**UN Regulation No. 145 (ISOFIX anchorage systems,
ISOFIX top tether anchorages and i-Size)**

Proposal for the 01 Series of Amendments to UN Regulation No. 145 (ISOFIX anchorage systems, ISOFIX top tether anchorages and i-Size) *

Submitted by the expert from the Netherlands

Model A
(see paragraph 4.4. of this Regulation)

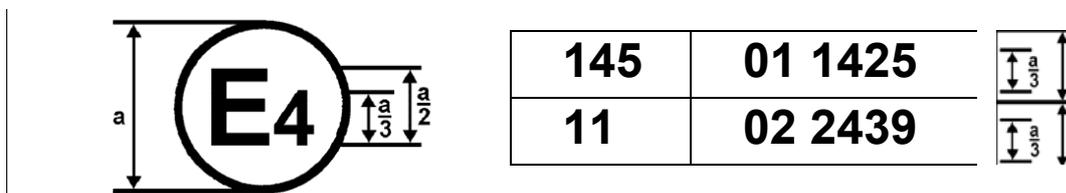
The above approval mark affixed to a vehicle shows that the vehicle type concerned has, with regard to ISOFIX anchorages systems, and ISOFIX top tether anchorages and i-Size seating positions -belt anchorages, been approved in France (E 2), pursuant to UN Regulation No. 145, under the number 011424. The first two digits of the approval number indicate that the approval was granted in accordance with the requirements of UN Regulation No. 145 01 series of amendments.

Figure 1
Lower Tether Anchorage Zone: Side View
 (Dimensions in millimetres)

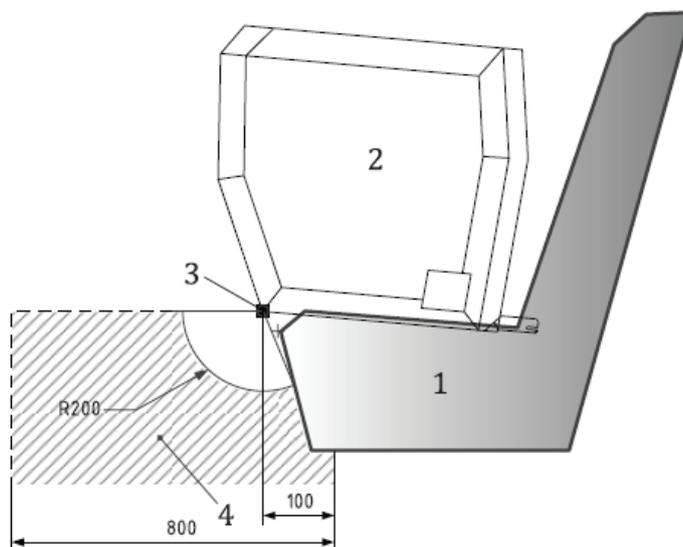
"Annex 6

Lower Tether Anchorage Zone and the Position of the Force Direction Reference Point

- Key:**
1. vehicle seat illustration.
 2. ISO/R2 envelope installed in related vehicle seating position.
 3. reference point on ISO/R2 envelope for LTA zone measurements.
 4. lower tether anchorage zone in side view, with upper limitation.
 5. where the LTA is integrated with the seat in front, the zone requirements have to be fulfilled independent of the height adjustment settings of the seat in front.

- 5.4.2. Number and Positioning**
- 5.4.2.1. Each intended ECRS position may be provided with a single or two LTAs, located within the zones shown in figures 1 to 3 of Annex 6 and according to the following specifications.**

- 5.4.2.1.1. For ISOFIX seating positions, a reference point for measurements is obtained by installing the ISO/R2 fixture in accordance with UN Regulation No. 16, in the vehicle seat. If adjustable, the seat shall be adjusted to its rearmost position.**

- 5.4.2.1.2. For non-ISOFIX seating positions, the reference point for measurements shall be obtained by installing the ISO/R2 fixture in the vehicle seat, using the envelope positioning procedure in Annex 7. If adjustable, the seat shall be adjusted to its rearmost position.**

Figure 2
Lower Tether Anchorage Zone: Top View

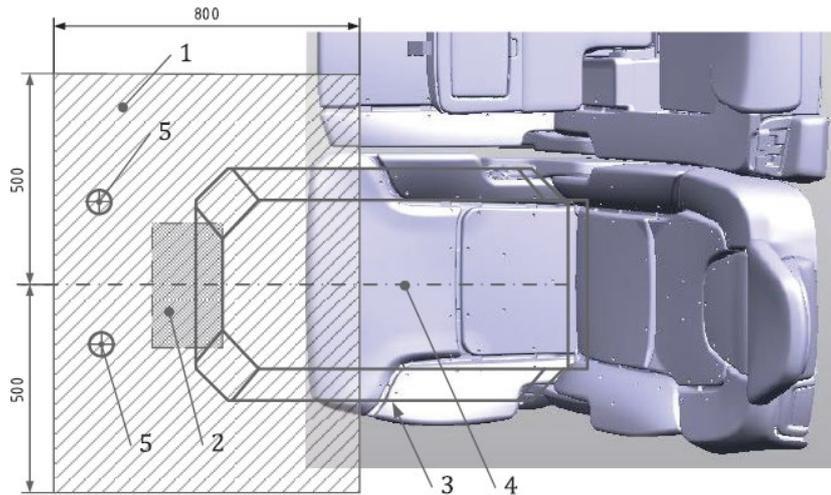
- Key:**
- 1. lower tether anchorage zone, top view.
 - 2. support leg zone (not to be used).
 - 3. ISO/R2 envelope installed in related vehicle seating position.
 - 4. centreline of ISO/R2 and ISOFIX anchorage positions (or the apparent centreline of the seating position in case of non-ISOFIX/i-Size seating positions, according to Annex 6) (contour only shown).
 - 5. lower tether anchorage, example positions

Note: The rearmost surface of the zone is positioned 100 mm rear of a vertical plane through the reference point on the ISO/R2 envelope. See Figures 5 and 6."

- 5.4.2.1.3. **If two lower tether anchorages are chosen, they shall be positioned with a minimum distance of 280 mm for the respective ECRS position.**

- 5.4.2.1.4. **The two anchorages do not need to be symmetrically positioned with respect to the centreline through the fixture. However,;**
 - 5.4.2.1.4.1. **Anchorage shall not be positioned on the same side of the fixture centreline; and**

- 5.4.2.1.4.2. **The offset between the centreline of the installed anchorages and of the fixture should be no more than 200 mm measured perpendicularly from the centrelines.**

- 5.4.2.1.5. **If a single lower tether anchorage is chosen for the seating position, it shall be symmetrically positioned with respect to the centreline through the fixture within an offset of ± 50 mm.**

Figure 3
Force Direction Reference Point and Direction of Test Force

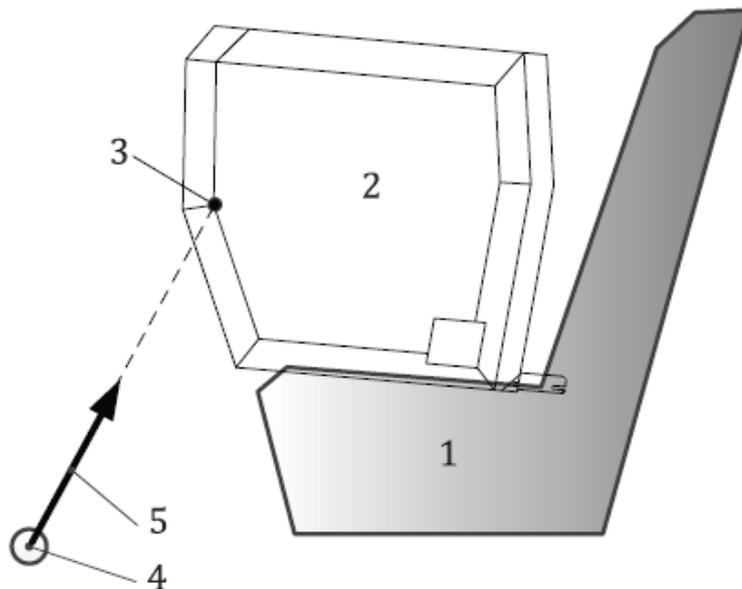
- Key:**
- 1. vehicle seat illustration.
 - 2. ISO/R2 envelope installed in related vehicle seating position.
 - 3. FDRP (force direction reference point).
 - 4. example of actual LTA position in vehicle.
 - 5. test force direction.

Note: The lateral position of FDRP coincides with the centreline of the ISO/R2 envelope"

- 6.3.4.1. Shall be applied in a direction determined by the FDRP (force direction reference point), with a tolerance of ± 20 mm in all directions given in figure 3 of Annex 6, noting that the FDRP lateral position coincides with the centreline of the ISO/R2 envelope;
- 6.3.4.2. Shall be attained within 30 s, and shall be maintained for a minimum of 0.2 s.
- 6.3.4.3. In case different FDRPs have to be covered, an individual FDRP which is ± 15 degree from the tested one, is considered to meet the requirements.
- 6.3.5. When testing in accordance with paragraphs 6.3.3. and 6.3.4., permanent deformation of the lower tether anchorage and bracket with respect to the vehicle is acceptable provided that the anchorage including its bracket does not break or separate from the vehicle."
